STRUCTURAL EVALUATION OF
RICHMOND HIGH SCHOOL
WEST CONTRA COSTA UNIFIED SCHOOL DISTRICT
(WCCUSD)

WLC Architects
Kaiser Building
1300 Potrero Avenue
Richmond, CA 94804

DASSE Design, Inc.
33 New Montgomery Street #850
San Francisco, CA 94105
(415) 243-8400

October 17, 2002

Drawing 1: Old Gymnasium Building (Unit B), Foundation Plan

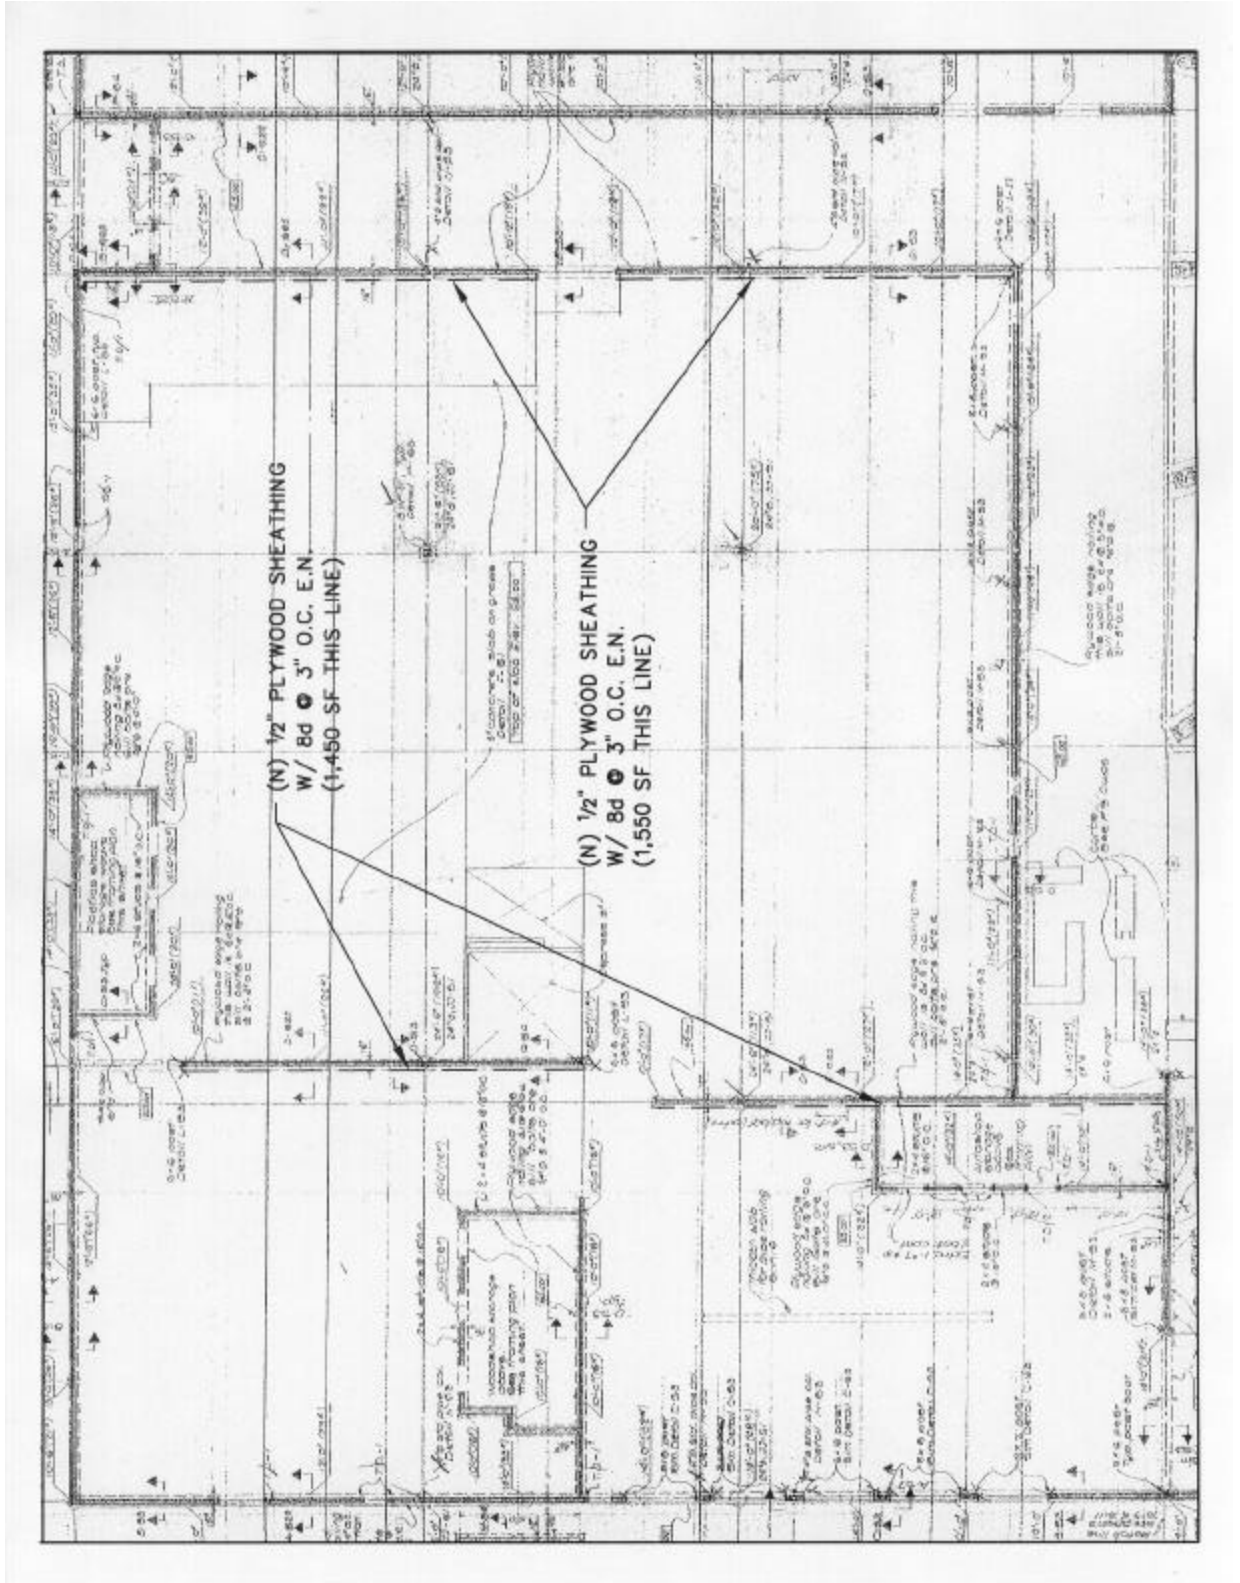
3.	Unit B: Masonry walls with extensive window openings lack adequate shear strength to resist the prescribed seismic forces.
4.	Unit B: Masonry wall anchorage connection lacks adequate strength to transfer the expected out-of-plane seismic forces.

5.	Unit B: Masonry walls lack adequate flexural strength to resist the expected out-of-plane seismic forces.
6.	Unit B: Horizontal diaphragm truss composed of steel tension rods and metal deck diaphragm lacks adequate strength to resist the expected seismic forces.

2.	Remove existing straight sheathing and provide new plywood sheathing at roof with nailing into existing framing.	1.0	N.A.
3.	Provide new concrete wall in-fill at existing window locations with dowels into the existing masonry wall.	1.0	1, 2

4.	Strengthen concrete wall anchorage connection with new wall anchors and diaphragm ties.	1.1	2, 3
5.	Provide new steel "strong back" columns from the floor to roof diaphragm with anchors into existing concrete walls.	1.5	1

Drawing 5: Classroom Building 100 (Unit D), Foundation Plan

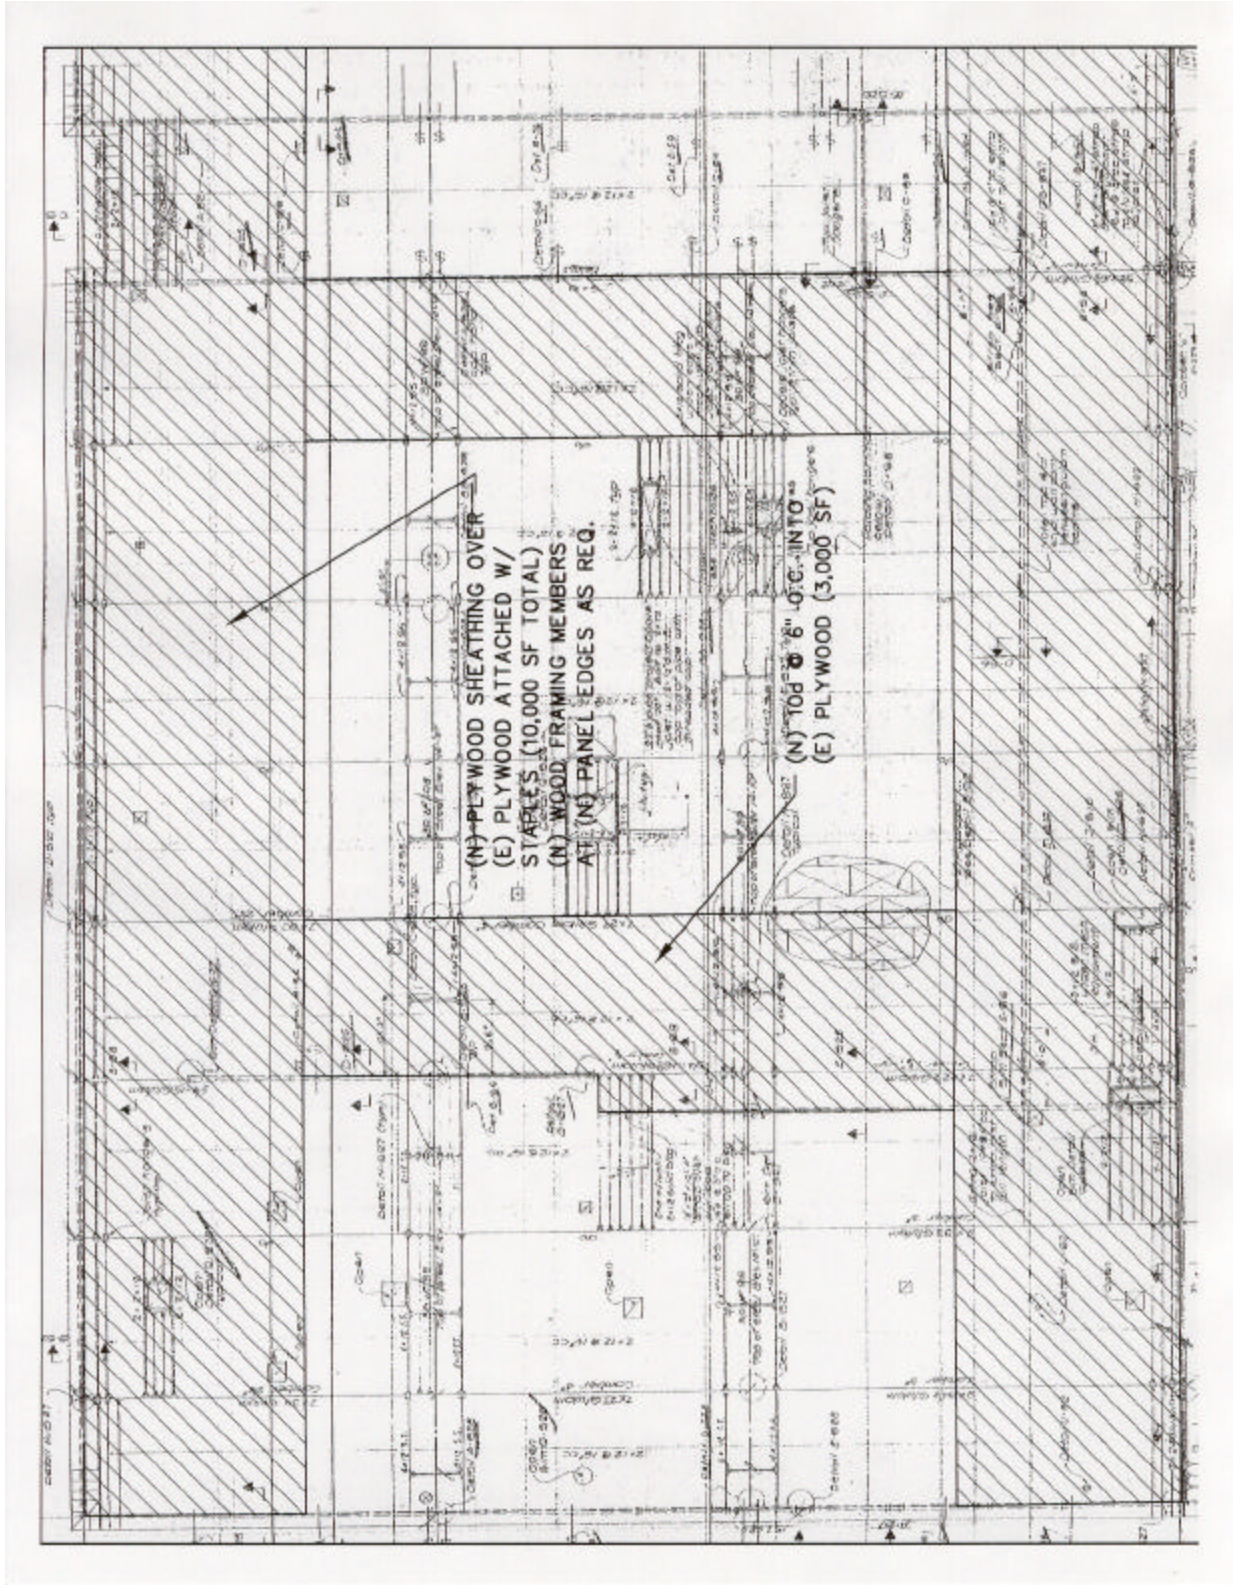
9.	Unit D, 100/200: Plywood sheathed walls lack adequate shear strength to resist the expected seismic forces.
10.	Unit D, 100/200: Plywood sheathed diaphragm lacks adequate shear strength to resist the expected seismic forces.

8.	Strengthen concrete wall anchorage connection with new wall anchors and diaphragm ties.	1.1	4
9.	Provide new second layer of plywood sheathing on the backside on the existing wood shear walls with edge nailing to match the existing.	2.0	5, 6

Drawing 9: Classroom Building 300 (Unit D), Foundation Plan

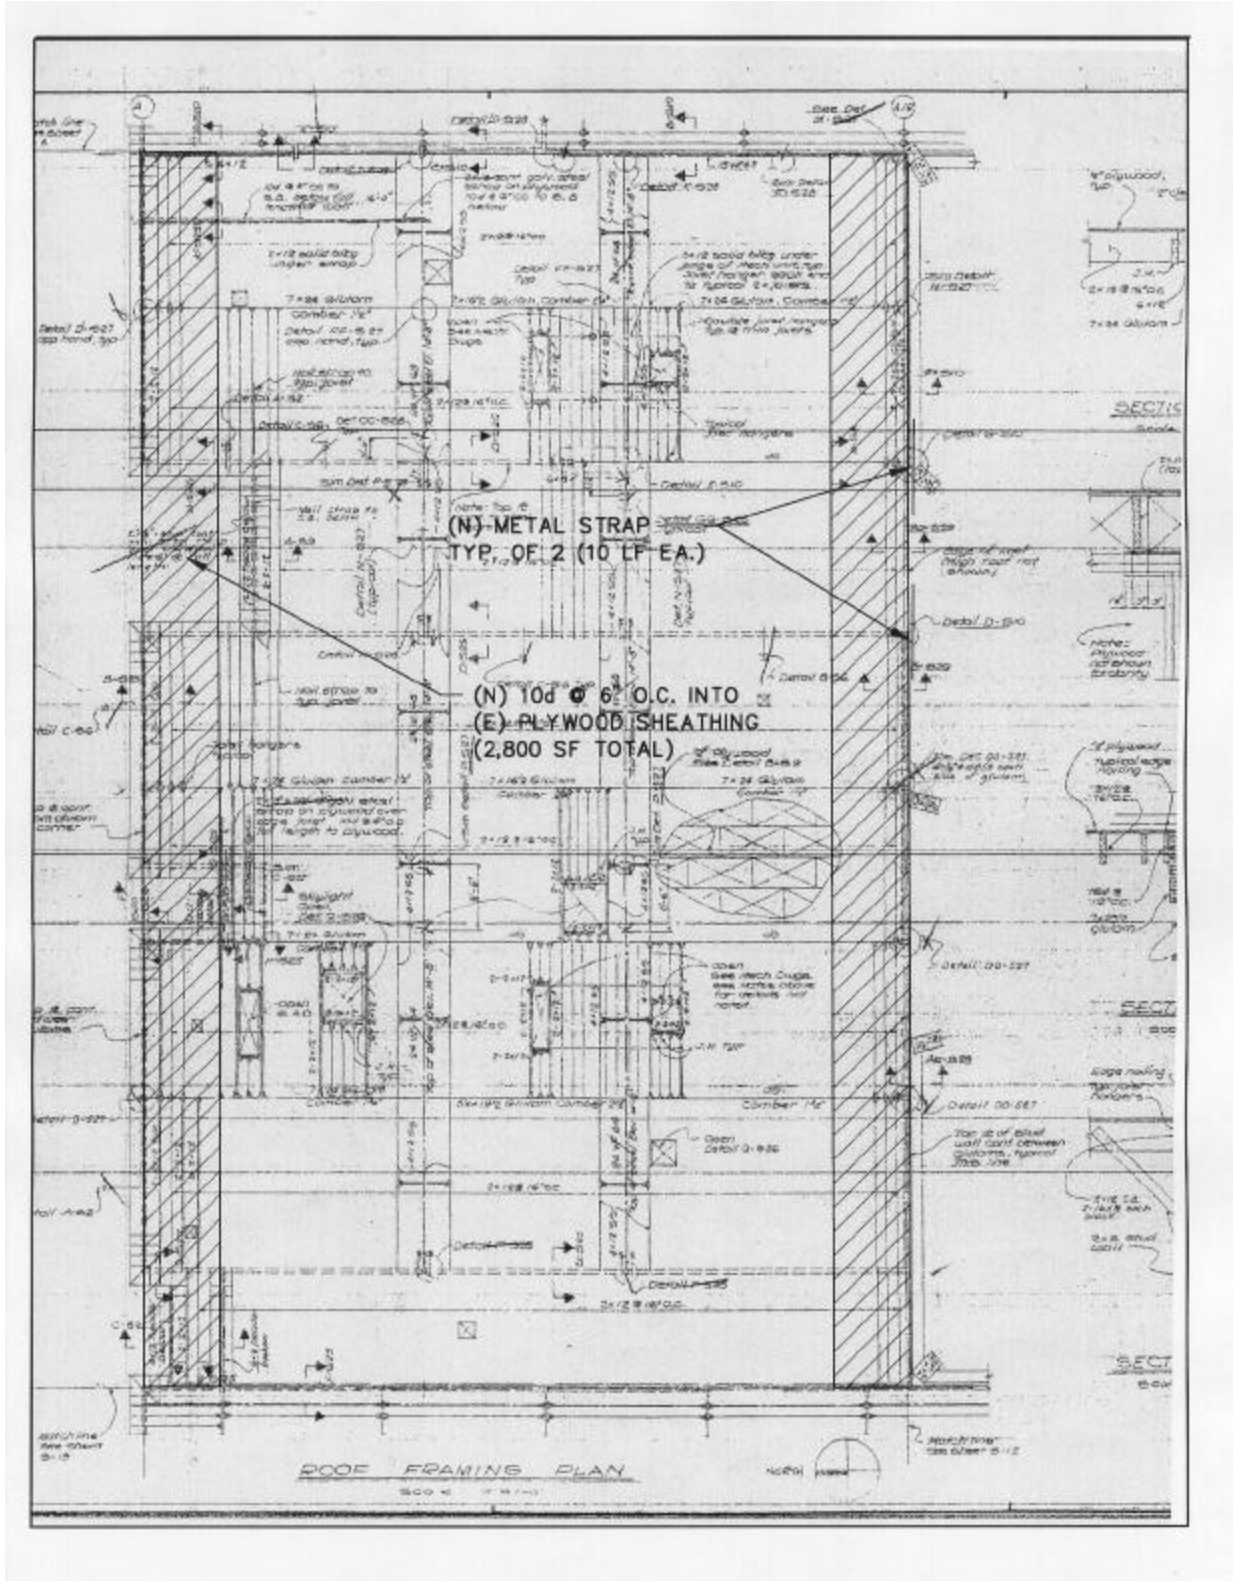
11.	Unit D, 300: Plywood sheathed walls lack adequate shear strength to resist the expected seismic forces.
12.	Unit D, 300: Plywood sheathed diaphragm lacks adequate shear strength to resist the expected seismic forces.

11.	Provide new second layer of plywood sheathing on the backside on the existing wood shear walls with edge nailing to match the existing.	2.0	9
12.	Provide new diaphragm nailing at existing plywood panel edges at critical locations.	2.5	10

Drawing 10: Classroom Building 300 (Unit D), Roof Framing Plan

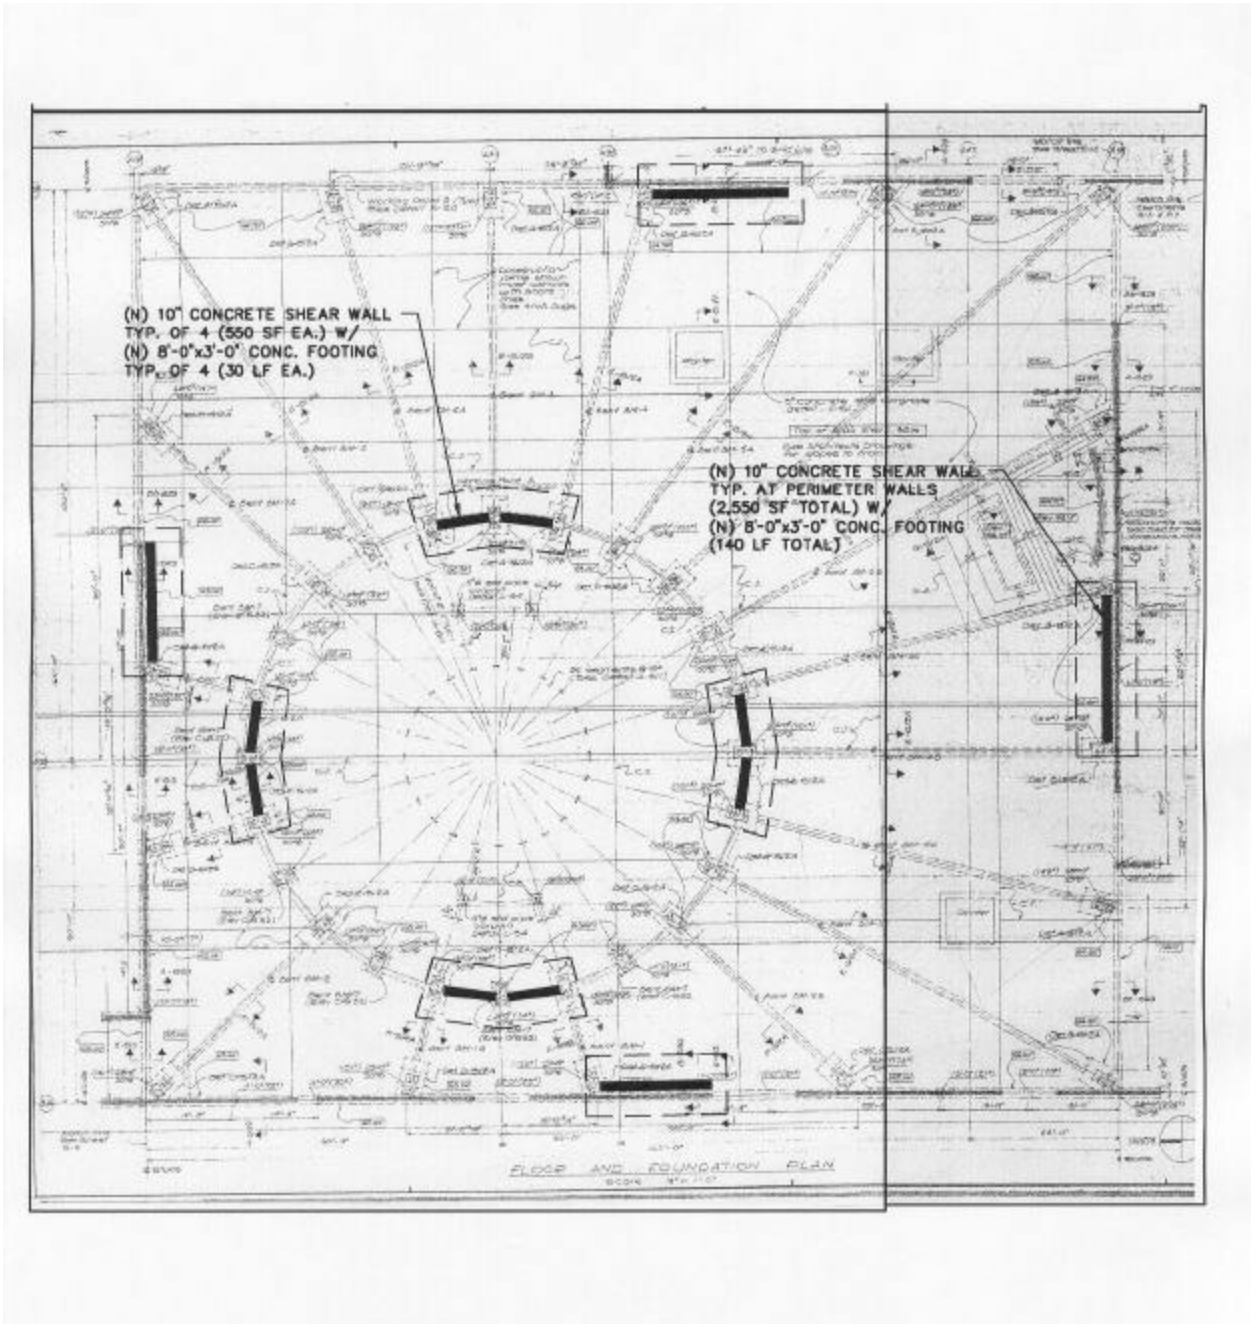
13.	Unit D, 300: Wood collector connections lack adequate strength to resist the expected seismic forces at critical locations.
14.	Unit D, 400: Plywood sheathed diaphragm lacks continuity and adequate shear strength to resist the expected seismic forces.

13.	Provide new metal strapping at critical locations.	1.5	10
14.	Provide new plywood sheathing over existing attached with staples. Provide new framing members at new panel edges as required.	1.1	12

Drawing 11: Classroom Building 400 (Unit D), Foundation Plan

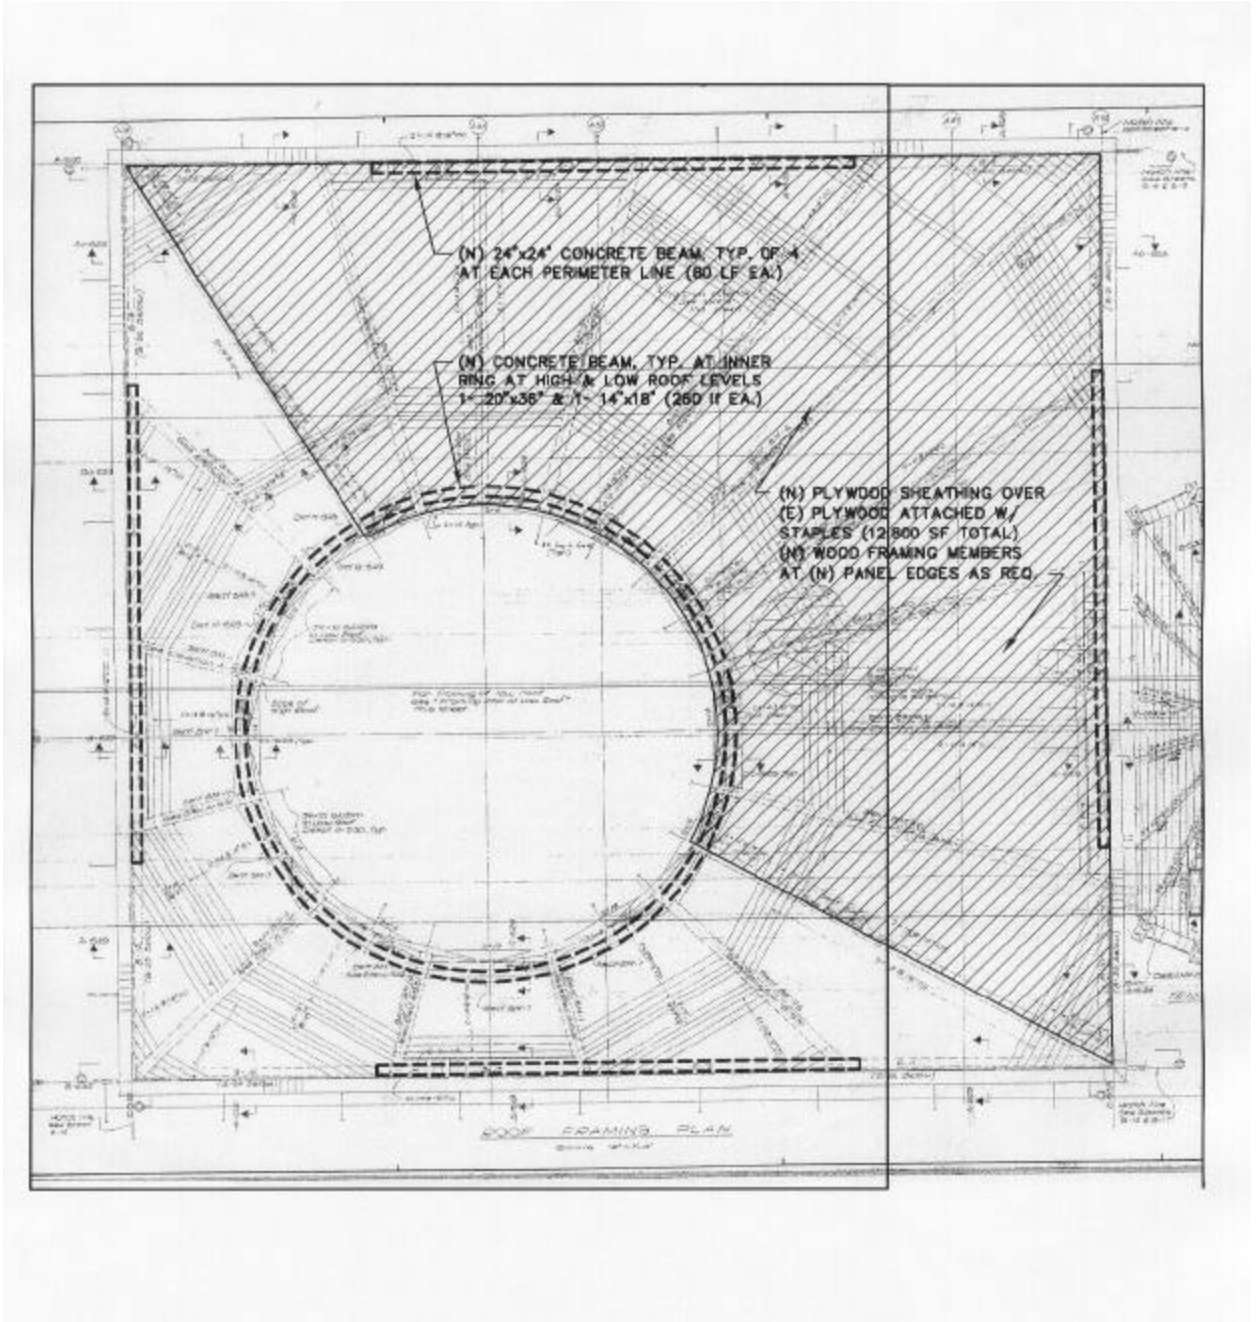
15.	Unit D, 400: Concrete moment frames lack adequate ductility and strength required to resist the expected seismic forces.
16.	Unit D, 400: Concrete collector beams lack adequate strength and lateral bracing to resist the expected seismic forces.

15.	Provide new concrete shear walls at perimeter frames and interior "ring" locations. Provide new dowels into the existing concrete columns. Provide new concrete footings.	1.1	11
